**Olive Branch Community Church, Site Plan Amendment, 82012020B**

Staff Report Date: 08/31/2018

**Description**

*Staff Recommendation: Approval with Conditions*

Image 1: West Elevation

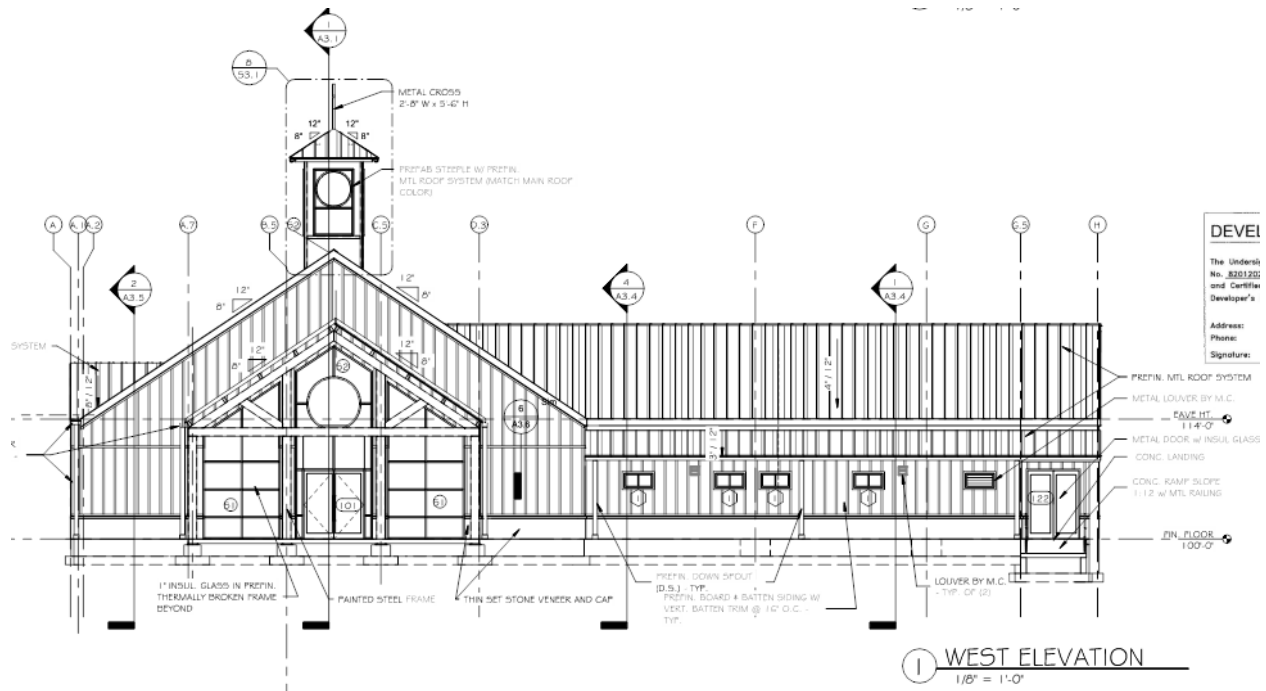
The Applicant proposes these changes to the prior approval primarily as a cost-saving measure as opposed to a true expansion of the church. While the floorplan as proposed overall has grown by approximately 1,000 square feet, the building is now a single floor and the sanctuary space retains the original capacity of 220 seats. The overall design is modest as compared to the original approval, among other things having reduced the overall visual mass by lowering the height of both the cupola and the roof peak, while proposing a change in building materials. The church retains an overall rustic appearance (Image 1) in fitting with the surrounding Sandy Spring's rural village environment.
